TNT WAREHOUSE AND DISTRIBUTION CENTRE (SSD 6040)

RESPONSE TO SUBMISSIONS

2-047-275903-DA - 200

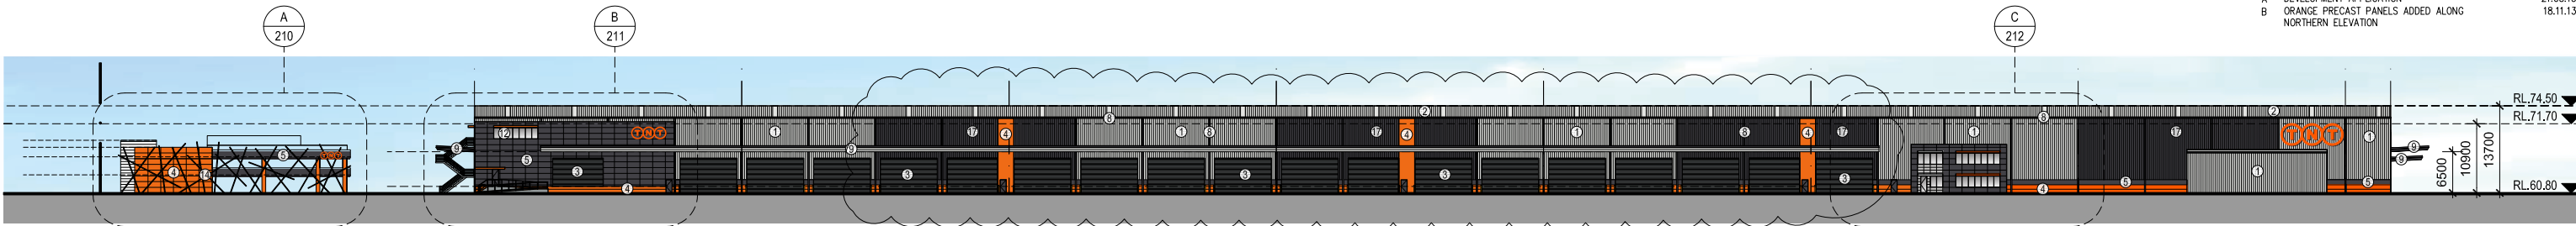
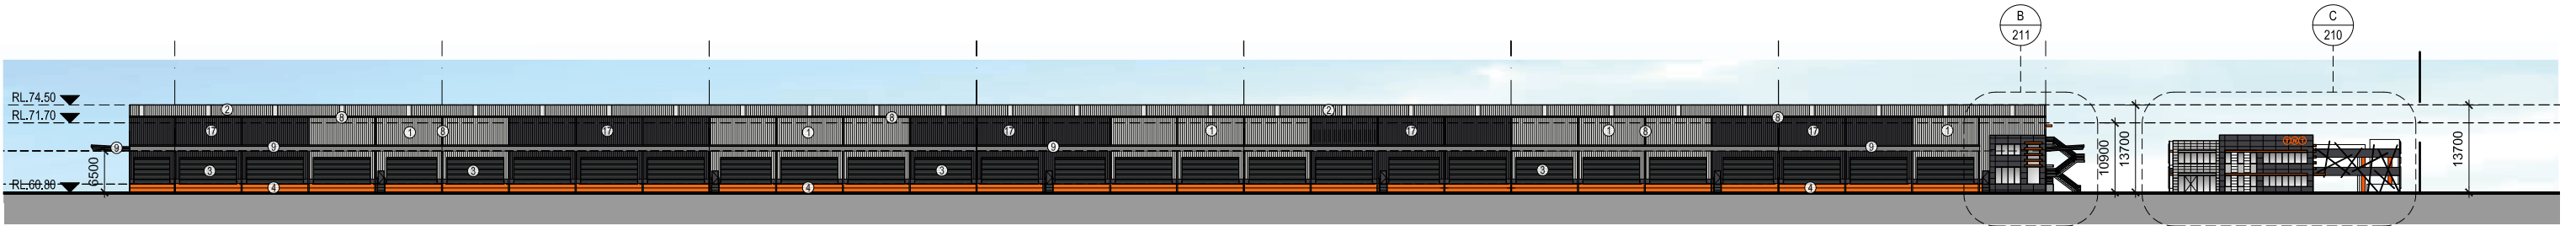
Penrith City Council	
<p>Architectural merit of the proposed building Consideration should be given to the design elements of the northern elevation of the building including:</p> <ul style="list-style-type: none"> • Breaking up the roof form; • Greater use of articulation and colour; and • Utilising exposed frames and oversized elements such as downpipes to create visual interest. 	<p>The northern elevation of the building has been improved by adding:</p> <ul style="list-style-type: none"> • Precast panels extending to the eaves line to breakup the roof form and geometry; • Additional colour to intersperse the corporate colour and help punctuate the wall panels; and • Oversized downpipes painted in contrasting colours to provide more contrast and visual interest. <p>Attachment 1(a) is revised drawing DA-002(B); Attachment 1(b) revised drawing DA 200(B); and Attachment 1(c) is a new drawing to the original DA set. This drawing DA 201(A) was added as the scale of the overall elevation was a little difficult to read at A3 size.</p>

A	DEVELOPMENT APPLICATION	21.08.13
B	ORANGE PRECAST PANELS ADDED ALONG NORTHERN ELEVATION	18.11.13

2-047-275903-DA - 002

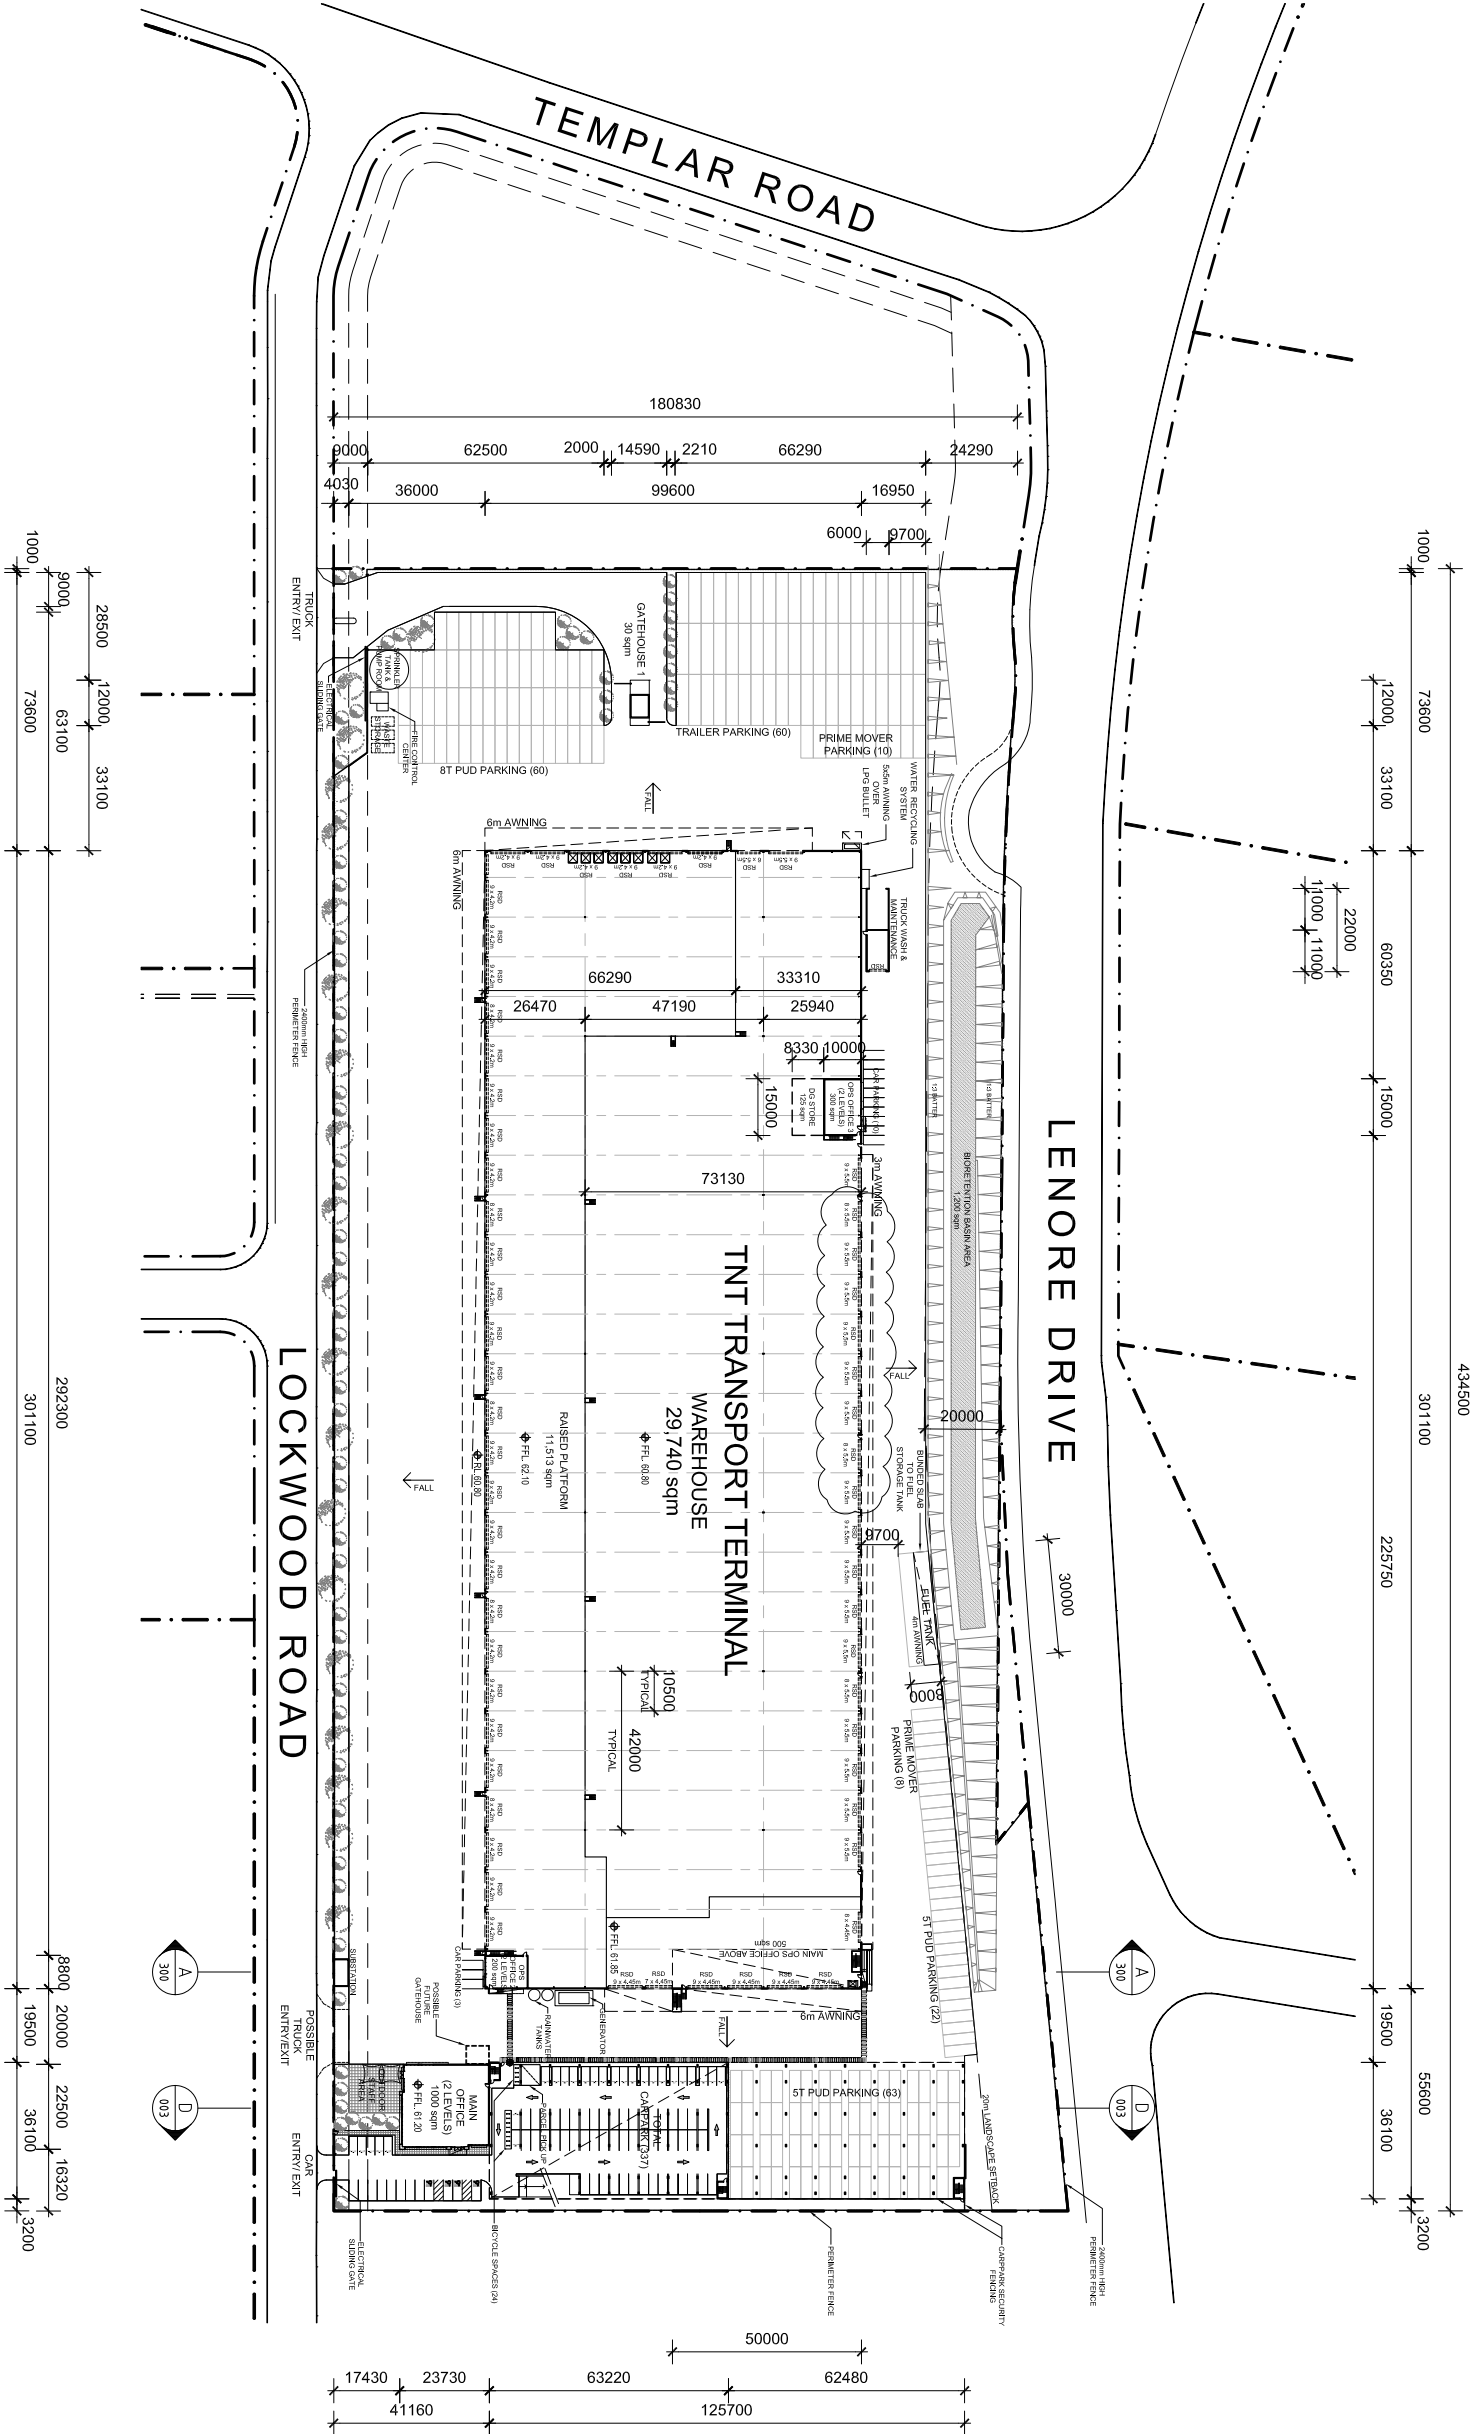
REVISIONS	DESCRIPTION	DATE
A	DEVELOPMENT APPLICATION	21.08.13
B	EGRESS DOORS & SMALLER RSD ON NORTH WALL RELOCATED TO SOIT VERTICAL PRECAST PANELS	18.11.13

2-047-275903-DA - 201

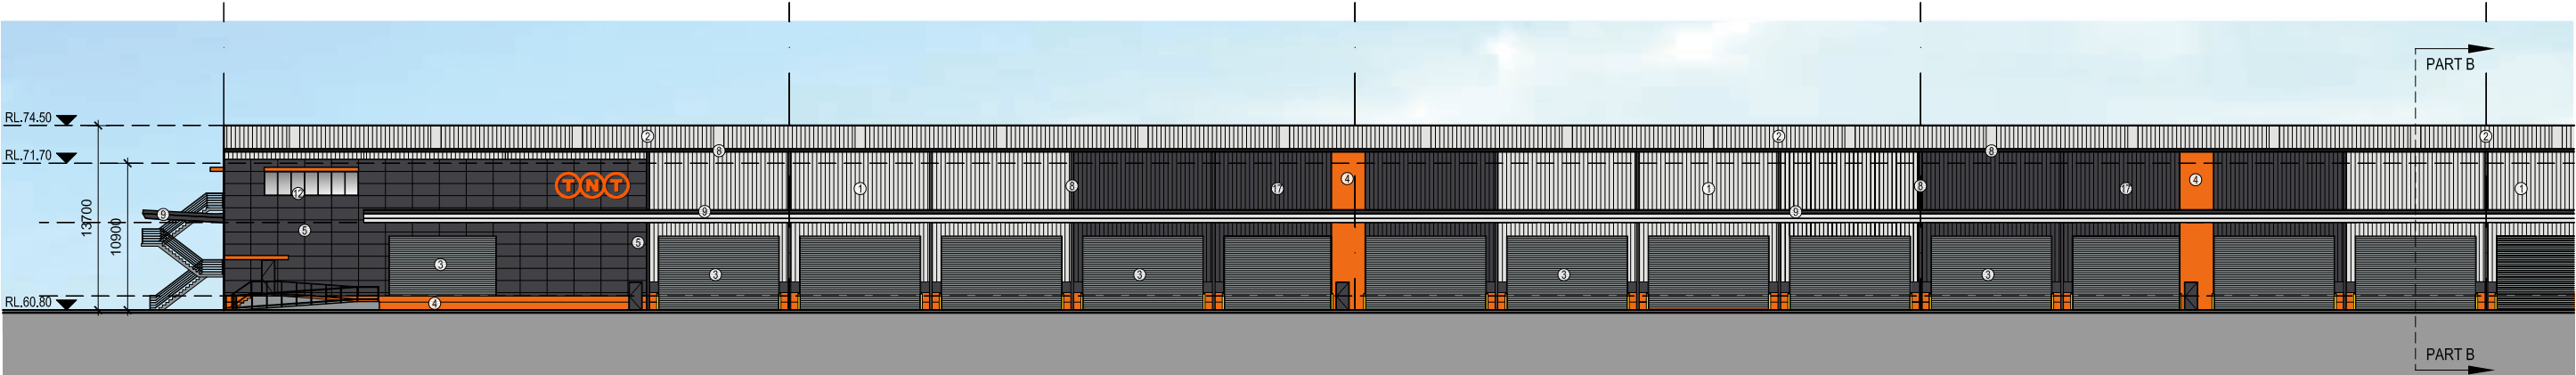
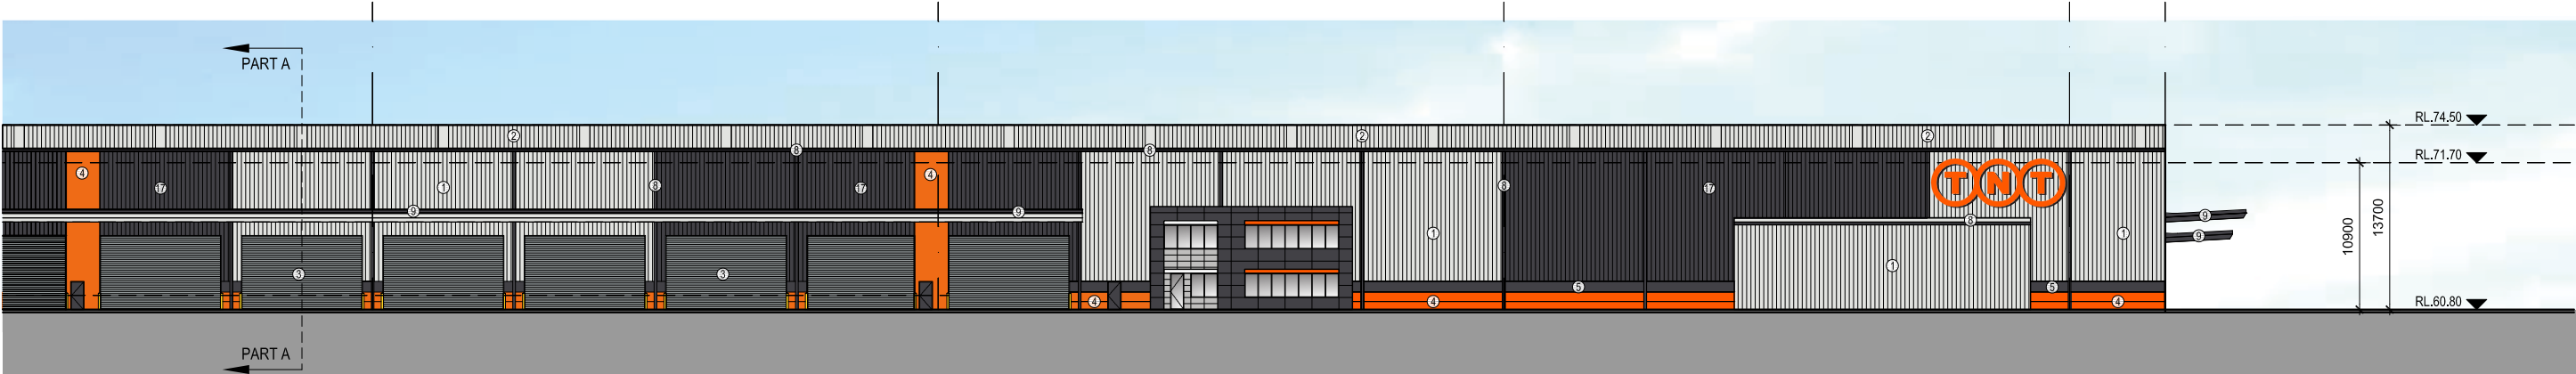
<p>Awning on the northern elevation Council considers the depth of the awning inappropriate to provide all-weather protection.</p>	<p>The awning has been specifically designed to meet TNT's requirements and is appropriate for their use.</p>
<p>Additional facilities Provision of sleep quarters/washing facilities within the building should be considered.</p>	<p>TNT considered the additional facilities Council suggests but decided to include a dedicated yard area for prime-mover parking instead. This will allow interstate drivers to sleep in their sleeper cabins where necessary. These drivers will be able to access amenities (shower, toilet and lunch room) at the site.</p>
<p>Landscaping and fencing The applicant is to use black, open style fencing to all boundaries with a high quality at the street frontage setback behind landscaping.</p>	<p>The development will incorporate black, open-style fencing to all boundaries behind the landscaping.</p>

DRAWING TITLE
SITE PLAN- RESIDUAL SITE

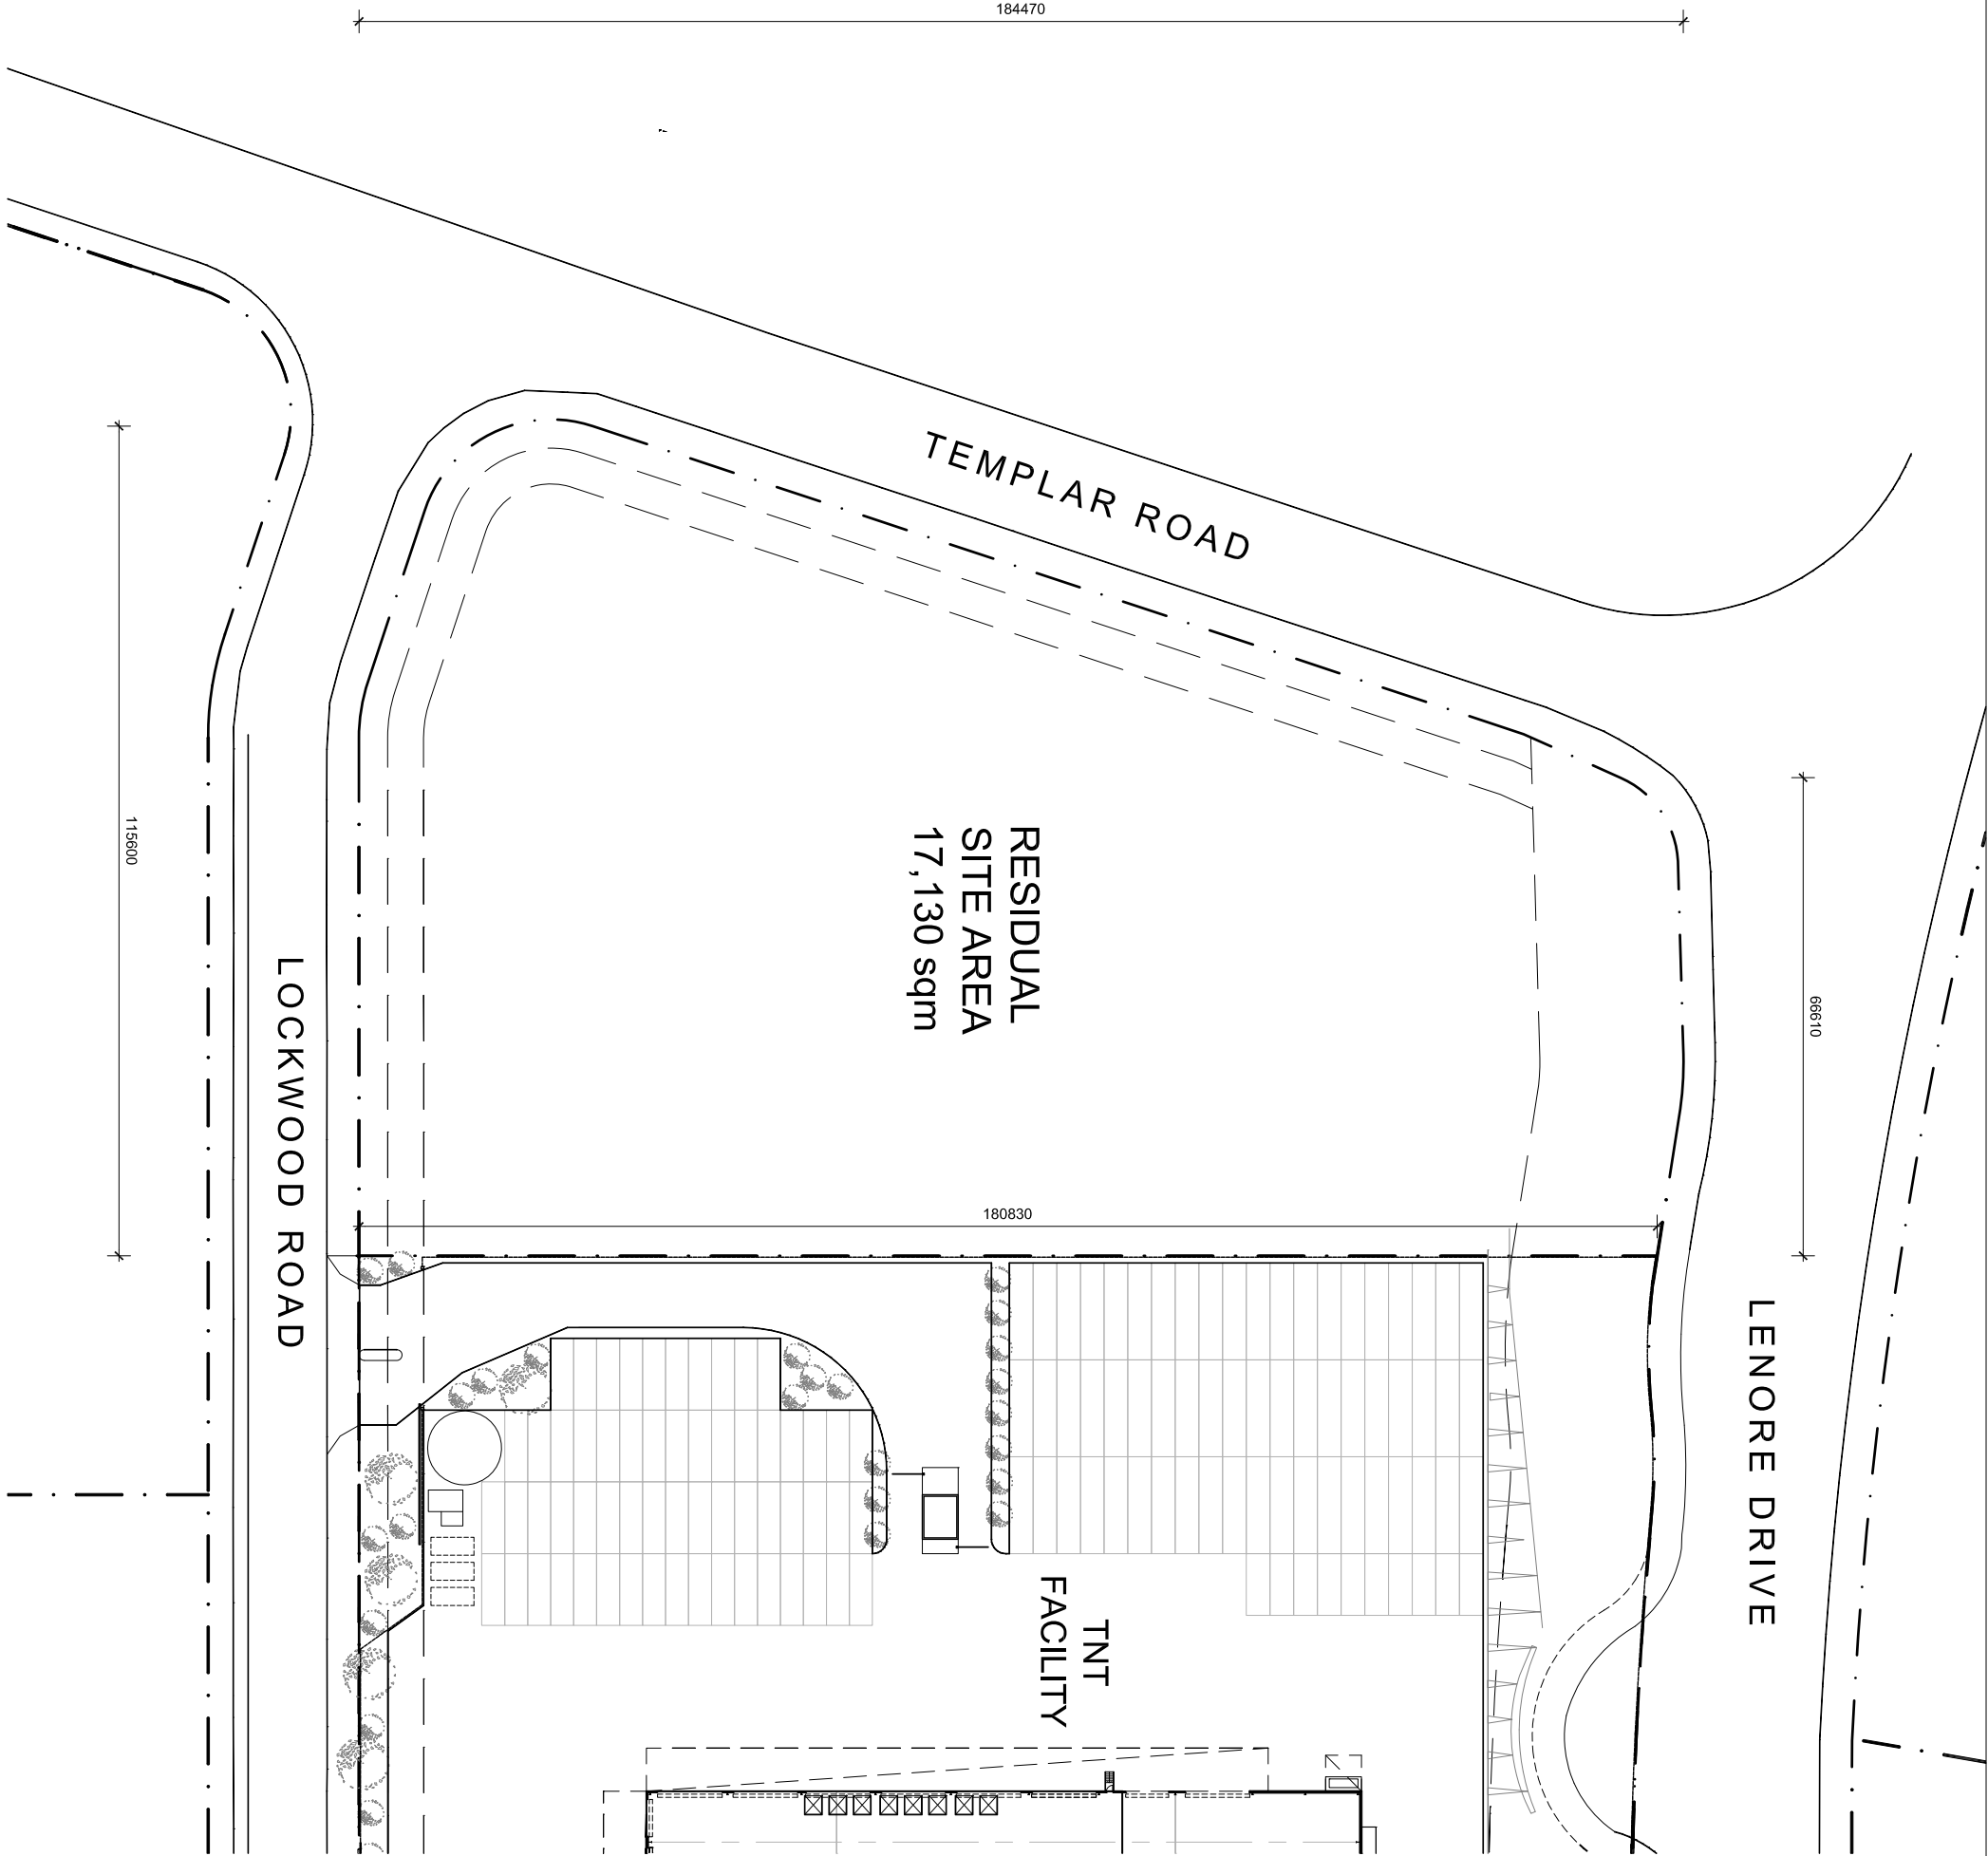
- A copy of the current (modified) approved Concept Plan layout
- Demonstration that proposed SSD 6040 is consistent with the terms of Concept Plan Approval 06_0208, particularly condition 1; and
- Provision of a plan showing the dimensions of the residual development parcel of site C.

A plan showing the residual area of site C is provided at Attachment 2. The plan identifies that the residual land has an area of 17,130m² in area which is well in excess of the minimum lot size of 10,000m² that applies under the DCP applying to the area.
